2. Item 1A

Appeal of Planning Commission Resolution No. 26-05 Regarding Coastal Development Permit No. 19-012 (25200 Pacific Coast Highway, APNs 4459-013-021 and 4459-014-018; Owner, PAR PCH, LLC; Appellant, Jun Hall for Concerned Citizens of Malibu Road, Inc.)

Amended[1] Malibu City Council
Special Meeting Agenda

Wednesday, August 19, 2026

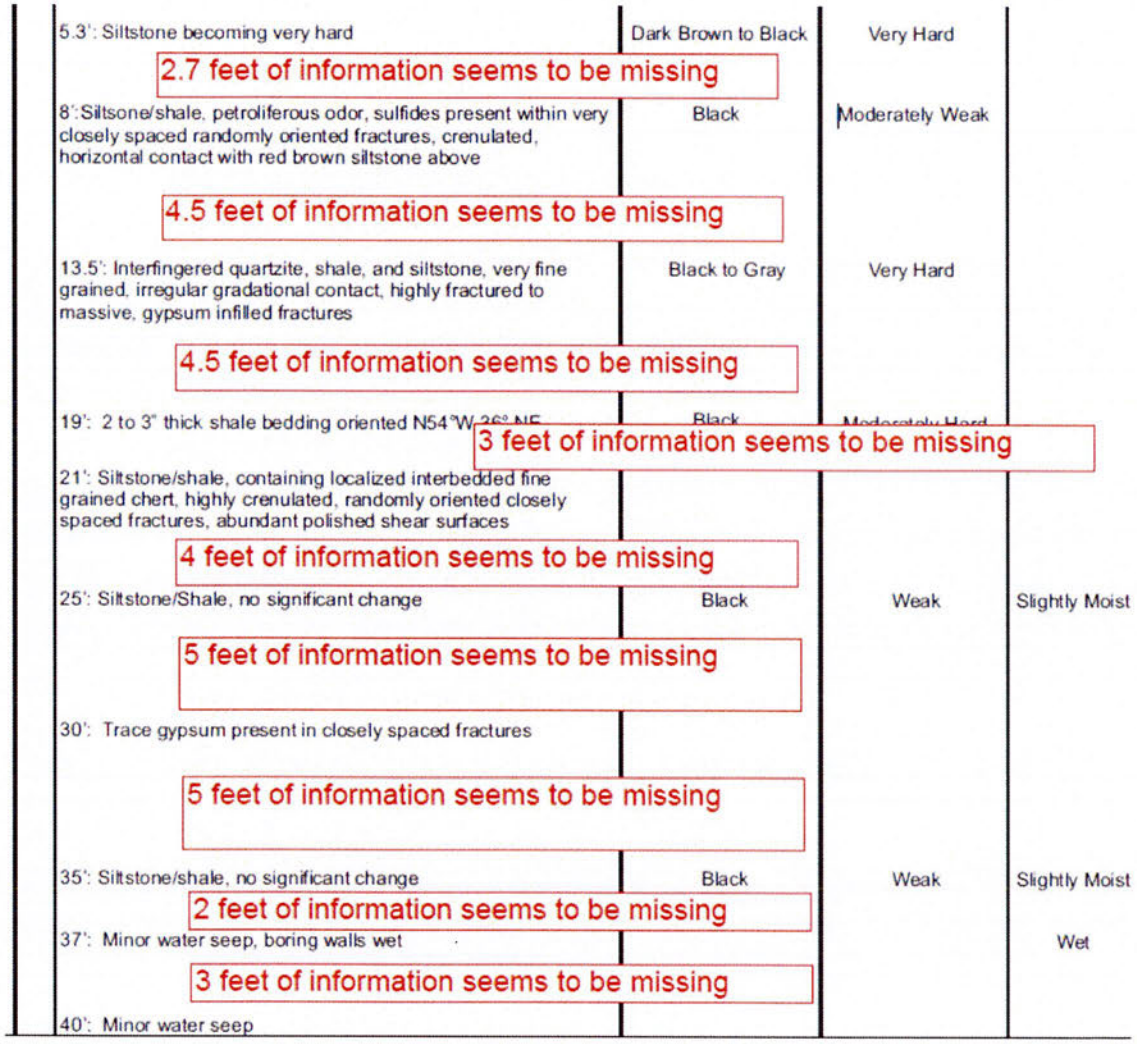
The concerns regarding the characterization of subsurface materials in Feffer's borings remain unaddressed. Specifically:

- Older consultants' reports documented crushed, disturbed, or sheared materials consistent with landslide deposits, while Feffer logs classify similar intervals as "bedrock" without explanation.
- Gaps in log descriptions at depth and a lack of detailed material characterization were not addressed and did not meet the industry standard of care.
- No explanation was provided for discrepancies between historic logs and Feffer's own interpretation.

As stated in the prior technical letter, continuous subsurface investigation is critical to defining landslide geometry and failure mechanisms. Continuous boring logs are essential. Industry standards require logging every vertical inch of the borehole and documenting lithology changes, shear zones, bedding attitudes, fractures, clay seams, and disturbed materials. Terms such as *smashed*, *jumbled*, *pulverized*, *reworked*, *slickensides*, and *polished shear surfaces* are commonly used to describe materials disturbed by landslide movement.

***Figures 7 & 8:** Appellant's photos which are clearly taken from the applicant's property and not from PCH, as is claimed in figure 8.*

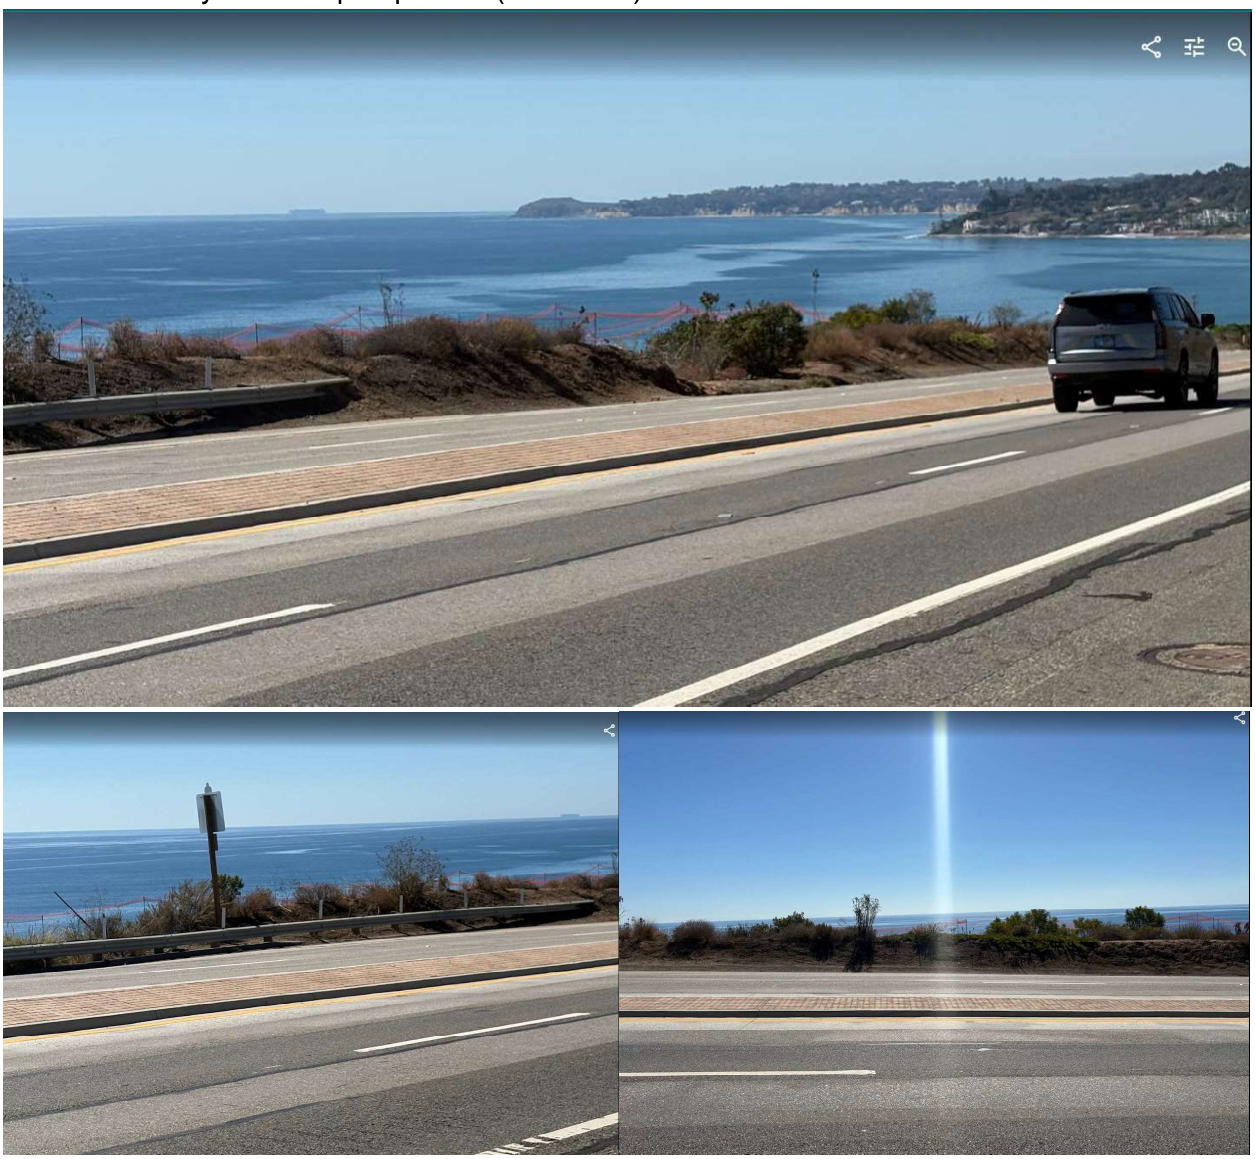
Again, the applicant's photos accurately show the relevant elevations of the story poles vis a vis the PCH roadway and berm. The applicant's photos below and the project rendering provide a clear picture of the minimal view blockage of the house design. Planning staff viewed the poles from PCH, photo documented the same and reviewed the applicant's renderings and have found them reliable and accurate as verified by staff's visits to the property. The appellants assertion

that the house blocks all views of Catalina and Palos Verdes is a contrivance supported by photos taken +-11' below PCH. The photos immediately below, taken by the applicant's representatives, show an entirely different perspective (from PCH).

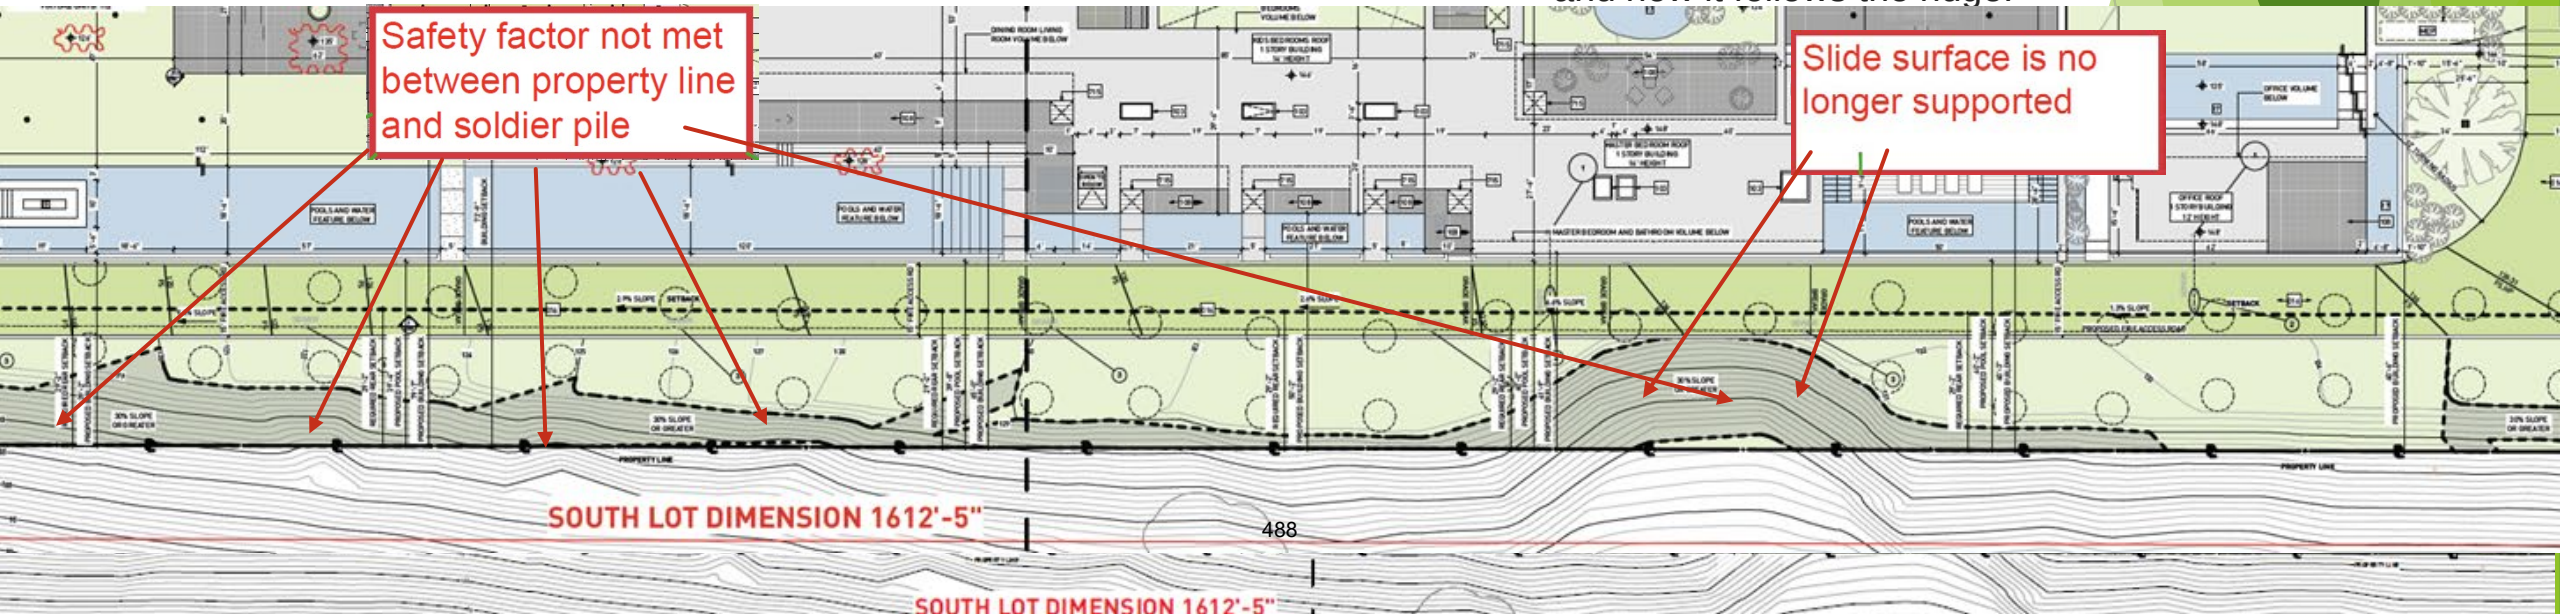
This is where the safety factor is clearly not met – They **moved/relocated** the soldier piles a few feet to avoid a slope variance and now they need a variance because there is space between the property line and the soldier piles where the safety factor is not met.

In addition, they are no longer supporting the slide in front of the MASTER area, and this would cause a slide into adjacent properties. This first image is before they moved the piles and shows the property line, it used to follow a straight line and now it follows the ridge.

Very FAR OFF the required 1.5 static factor of safety

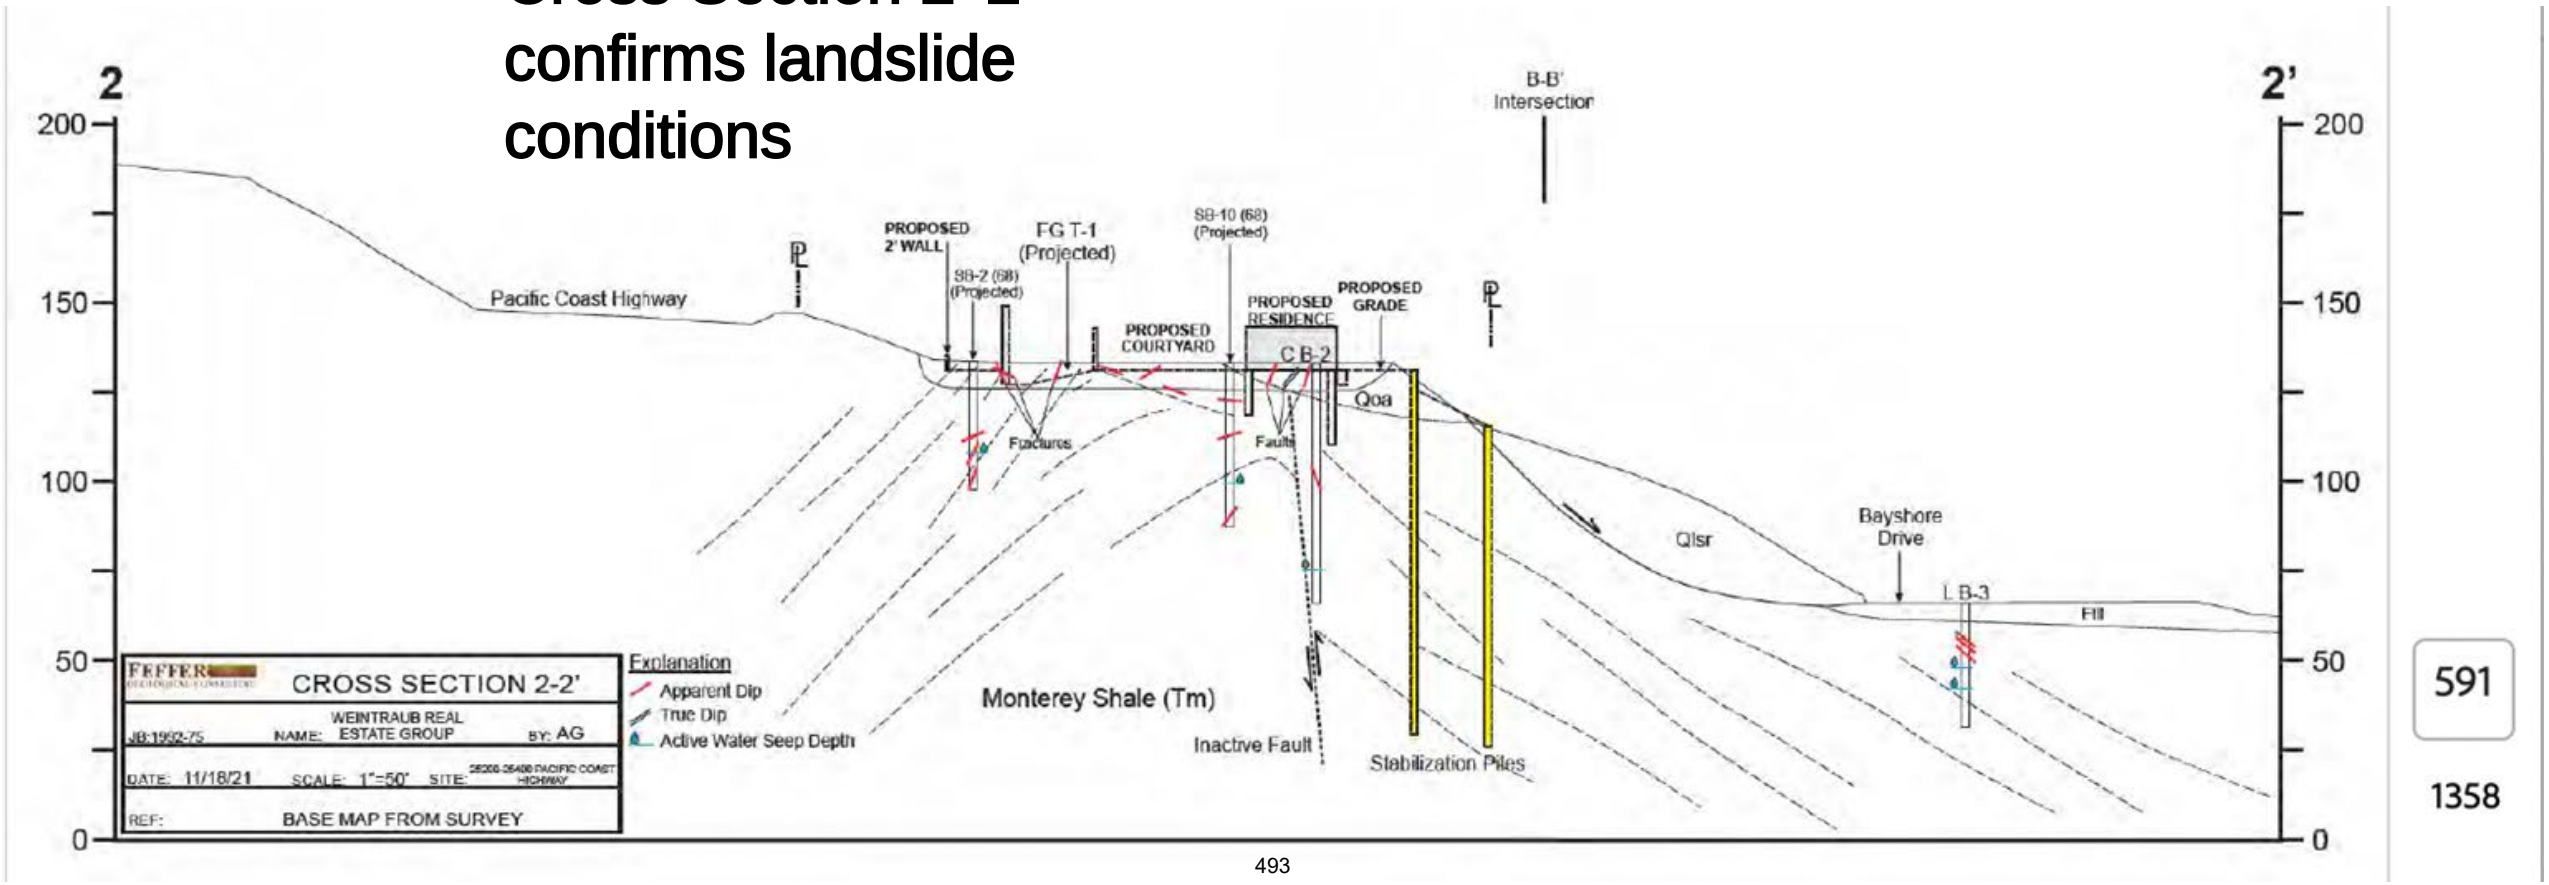
- Required minimum (LIP §9.4(D)): **1.5 static**
- Calculated results: **1.076 - 1.234**
- Values near **1.0 = marginal equilibrium / instability**

Pile Base Elevation vs Slide Base Elevation

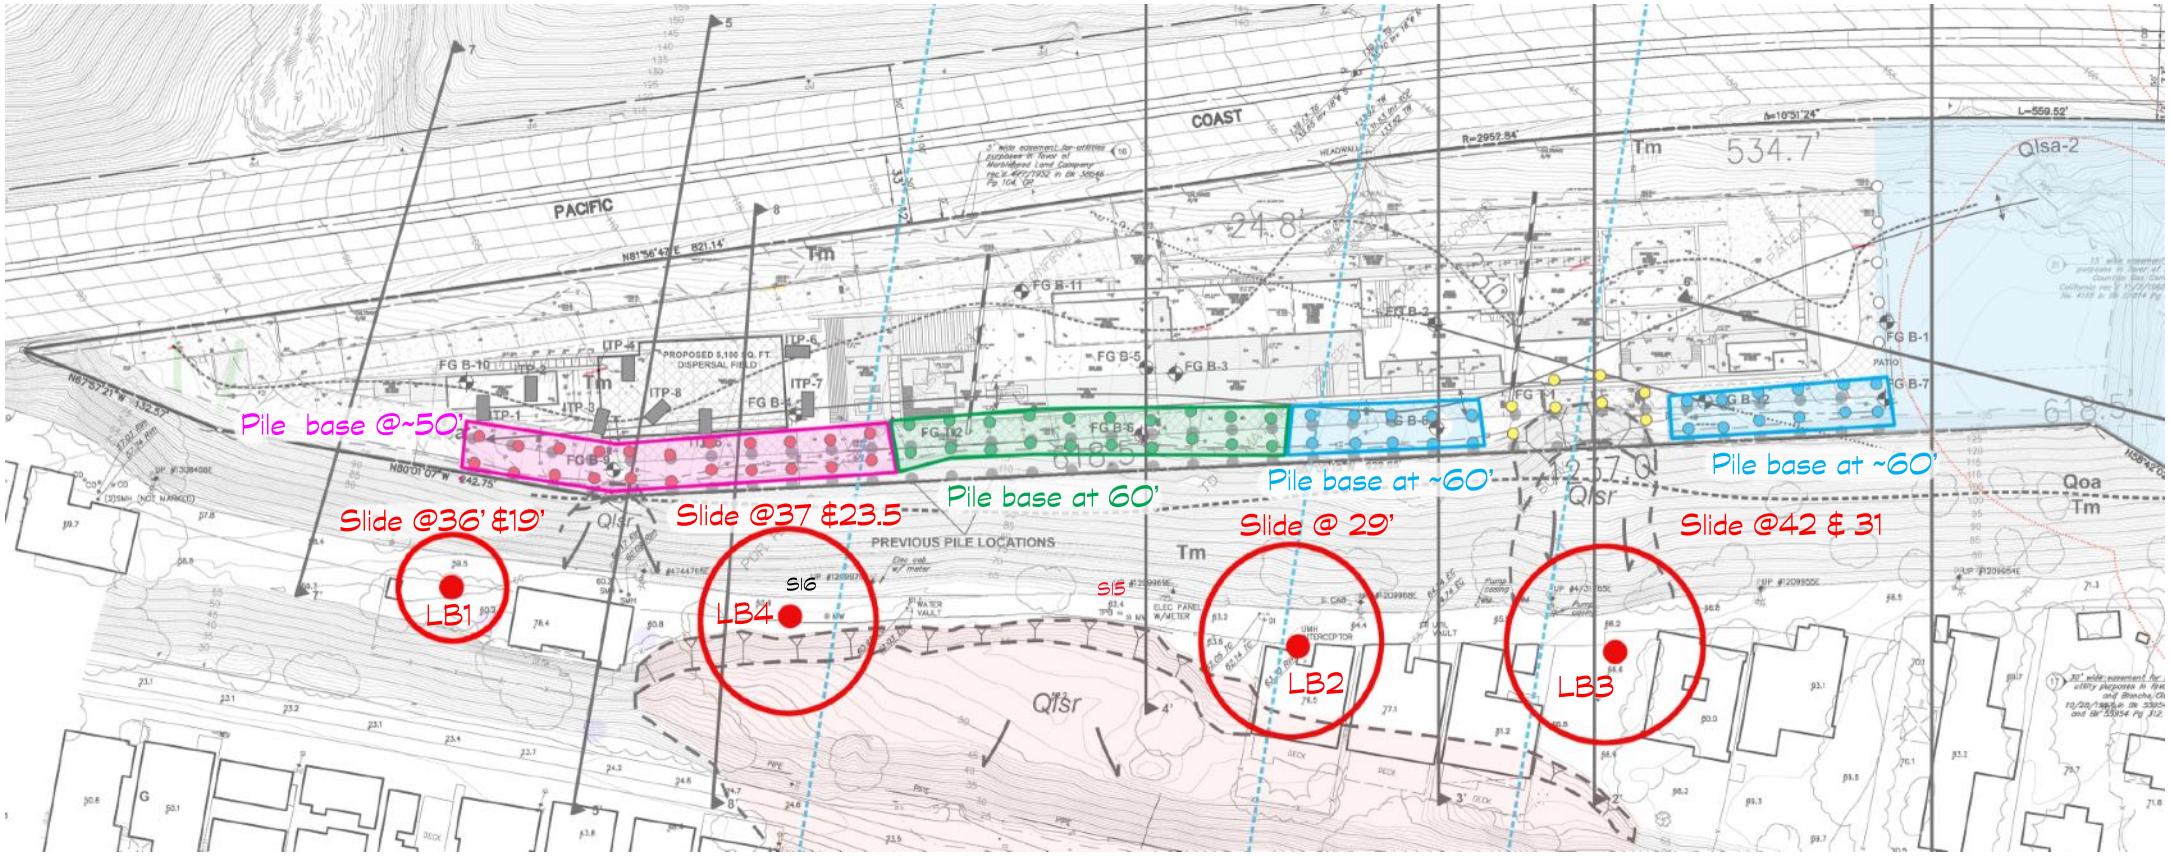
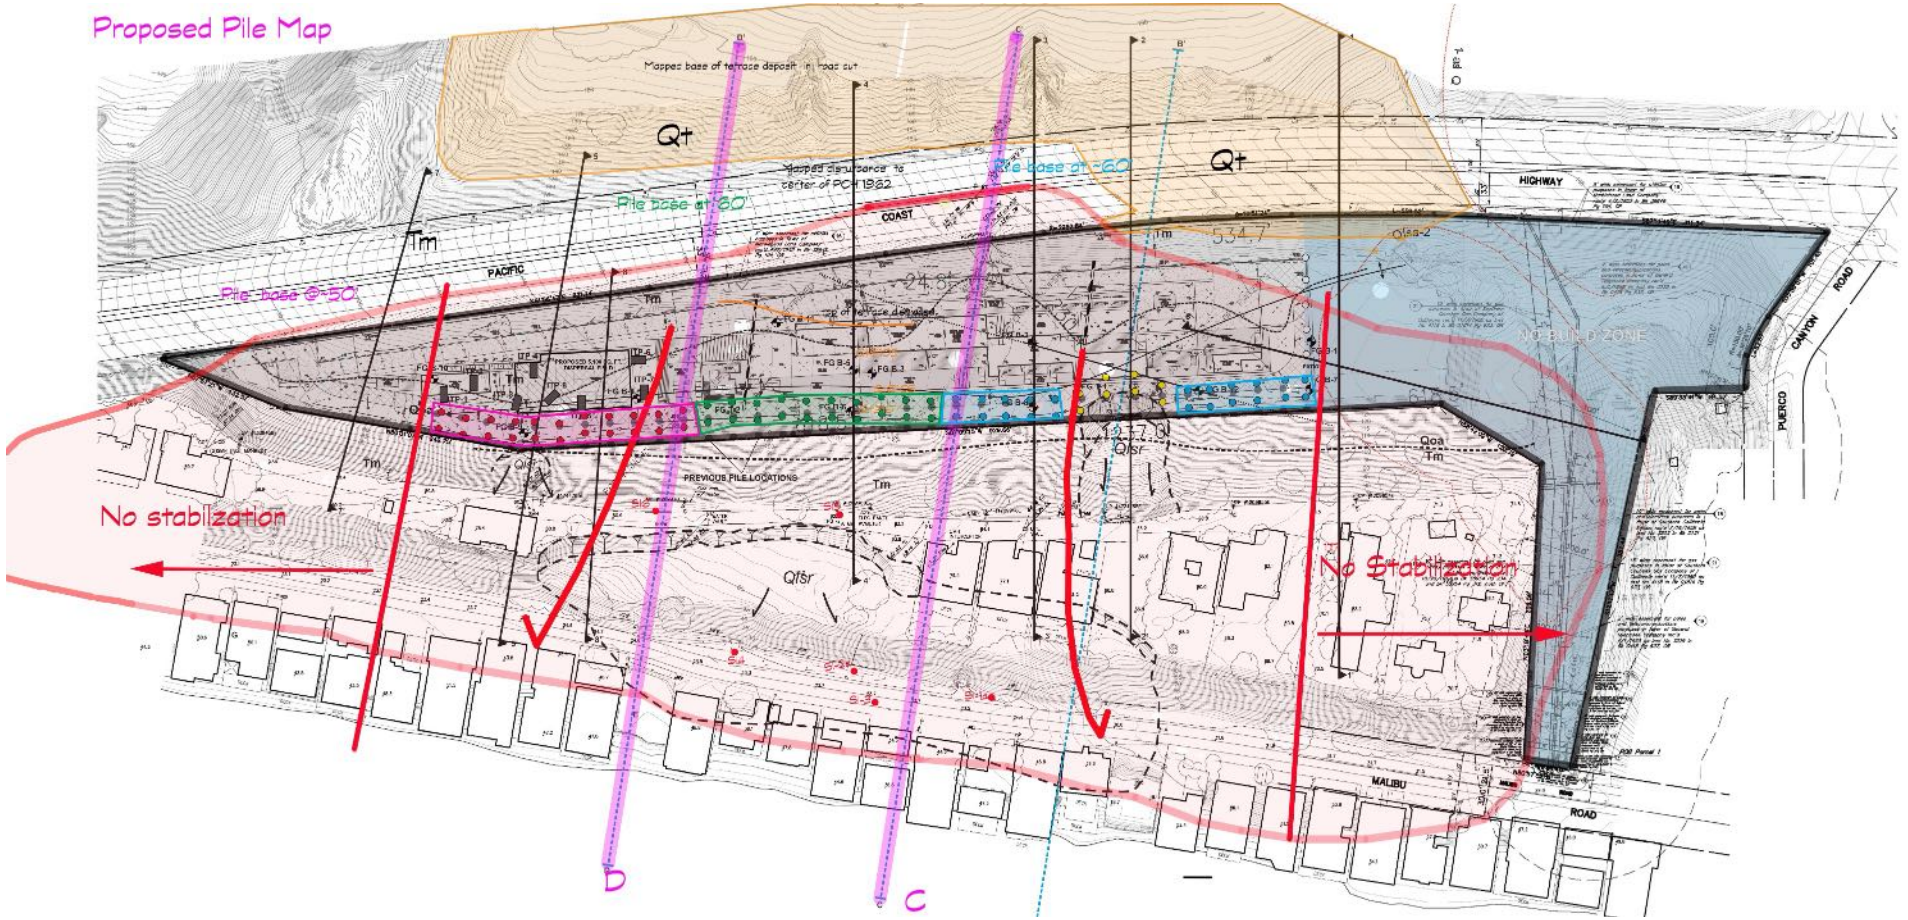
Pile color from map	Red	Green	Blue and Yellow
Depth/pile length	50’	60’	60’
Bottom elevation of pile	50’	60’	60’
Slide Plane Elevation	36’& 19’/37’23.5	37’-29’	29’-31’
Deficit	14’ to 31’	36.5’-31’	31’-29’
